Urban Design Planners Referral Response

REFERRAL RESPONSE URBAN DESIGN

1.1.2 FILE NO: Development Applications/ 359/2017/1

1.1.4 ADDRESS: 30-36 Bay Street DOUBLE BAY 2028

BASEMENT PLAN

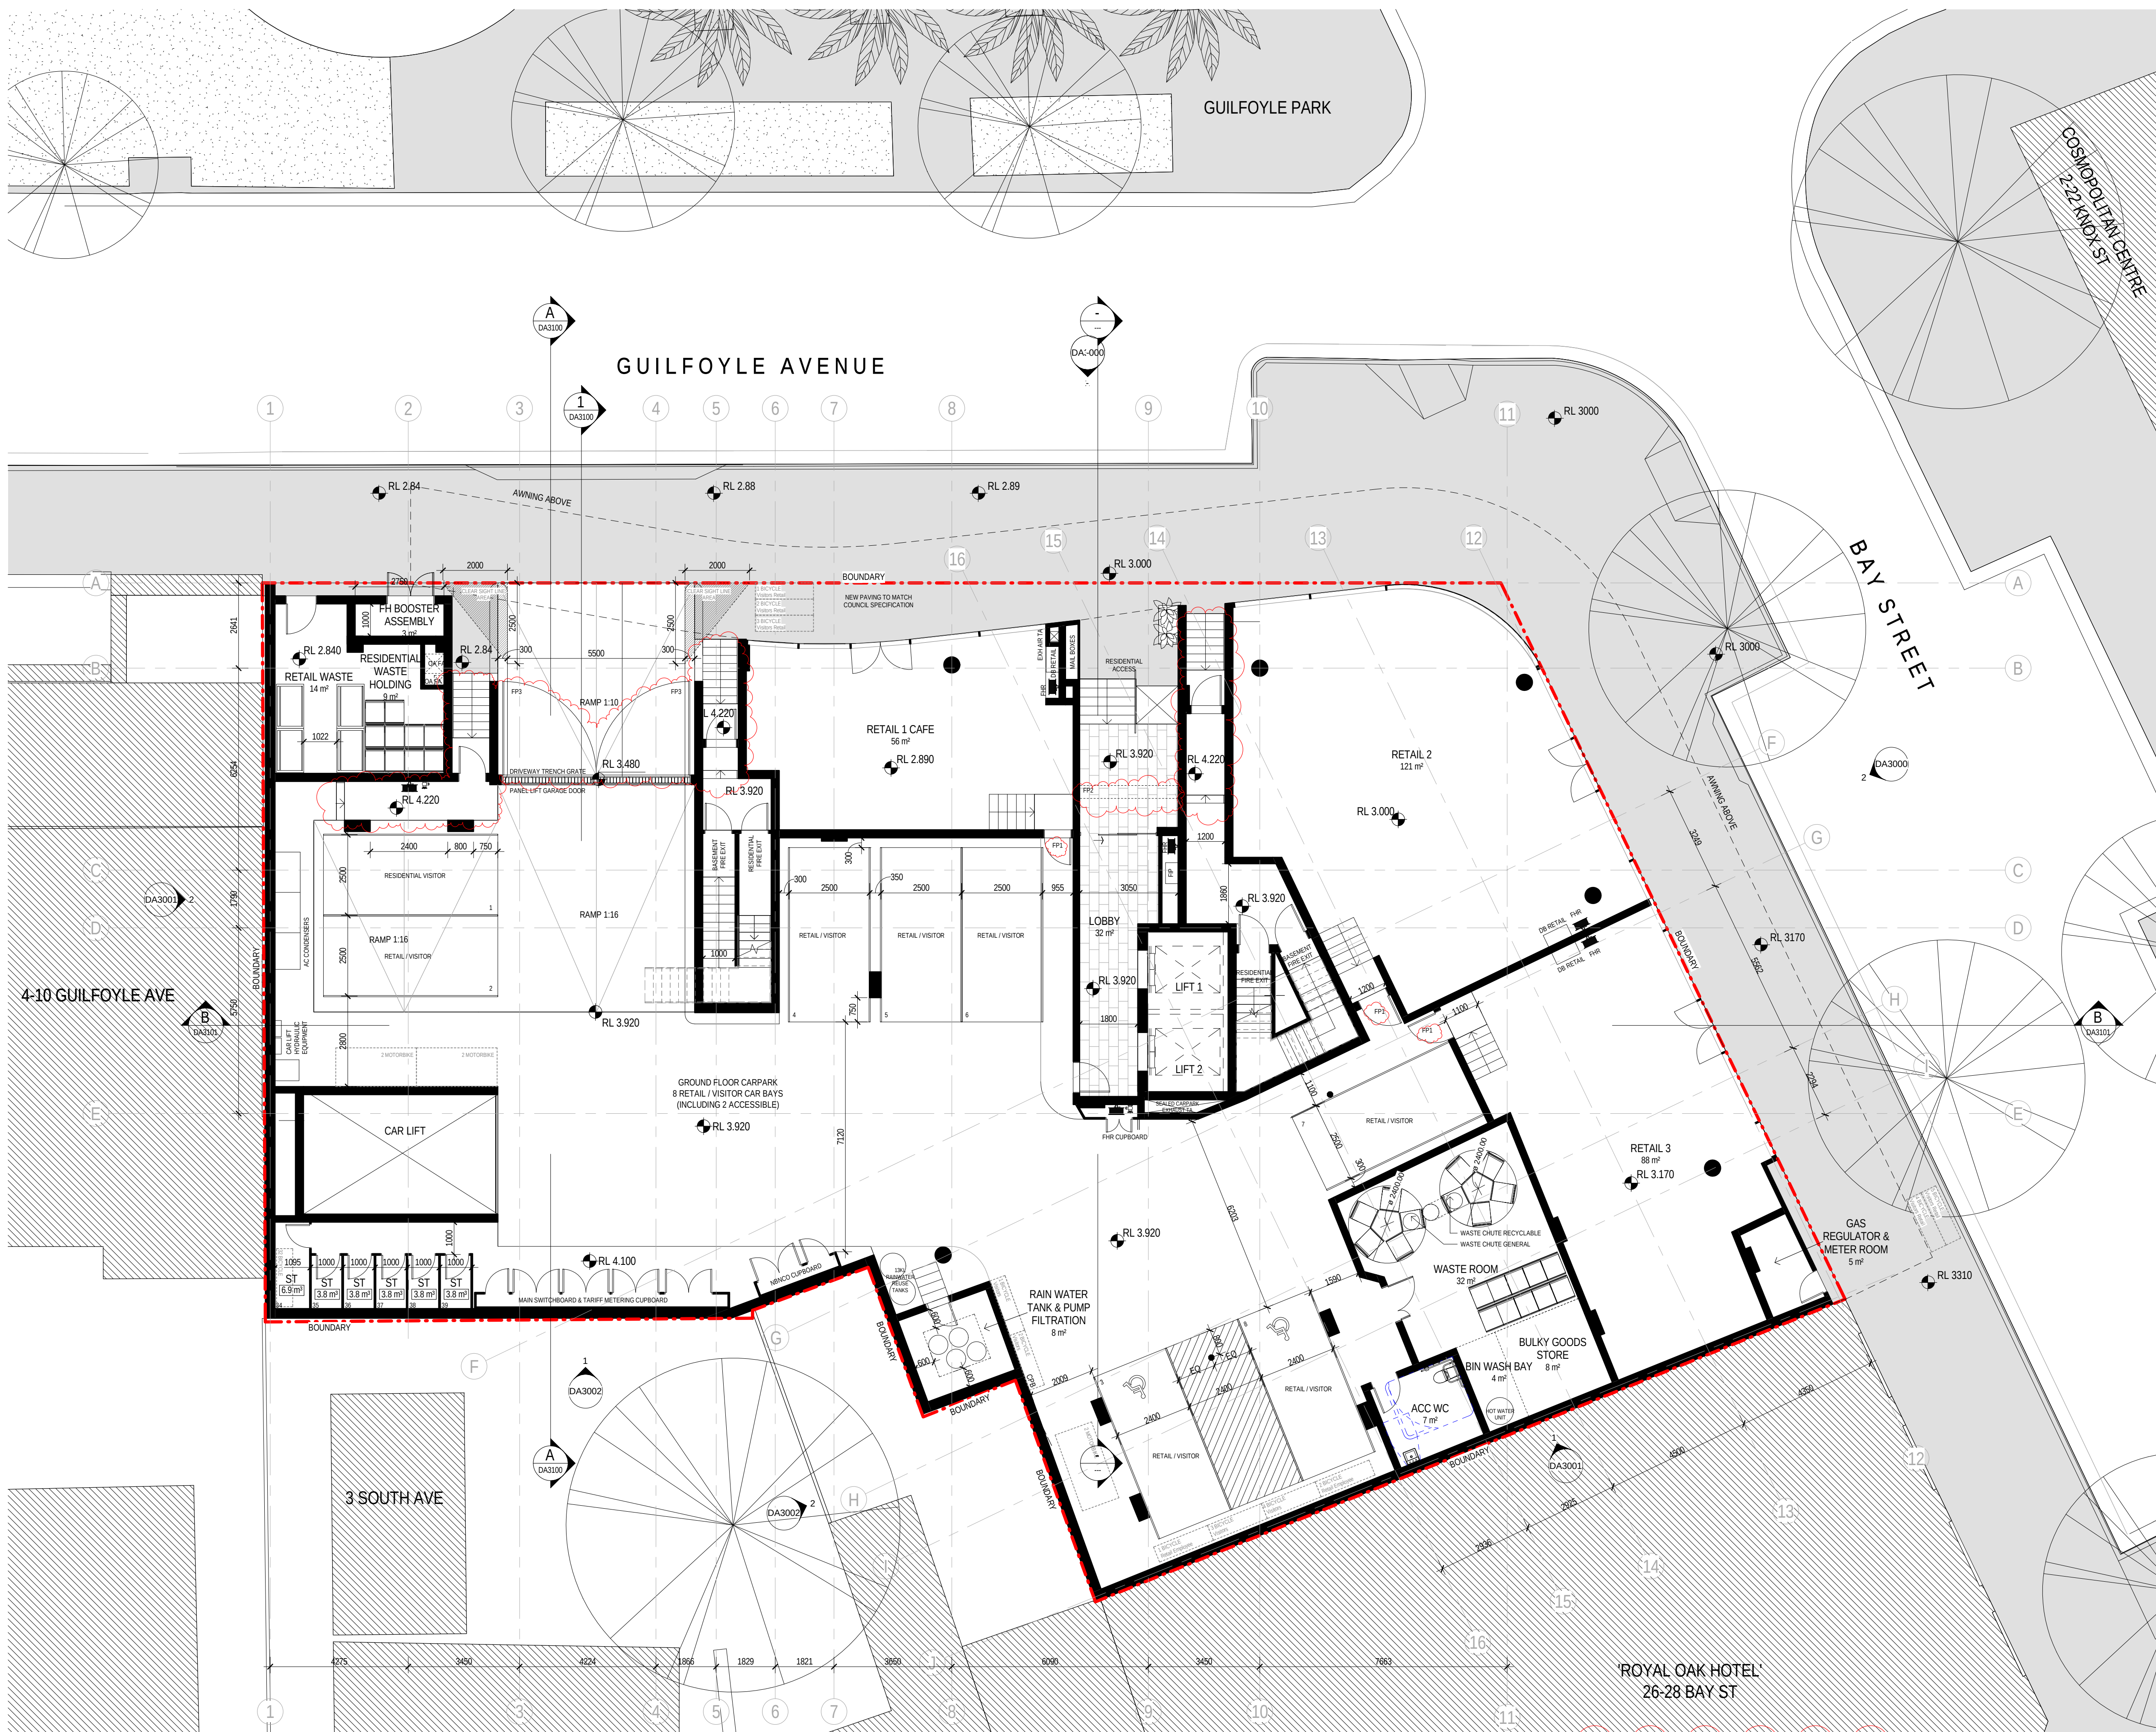
With reference to architectural drawing titled 'Basement Plan' and 'Ground Level Plan', a number of design deficiencies have been identified, as discussed below:

1. *Pursuant to Clause 2.2.1 of AS/NZS 2890.6:2009*, bollards shall be provided within the shared area in the positions shown in Figures 2.2 and 2.3.
2. *Pursuant to Clause 3.2.4 of AS/NZS 2890.1:2004*, a pedestrian splay shall be provided at the property line, west of the driveway.
3. The applicant must provide bicycle parking on-site. The applicant shall increase the resident bicycle parking spaces to 39 spaces, increase the motorbike parking spaces to three spaces and also alter the retail visitor bicycle parking to provide minimum four spaces for retail visitors on-site.
4. Considering that the proposed retail parking provision already exceeds the minimum requirement, it is recommended that at least one of the nine retail spaces is to be reassigned as full-time residential visitor parking space.
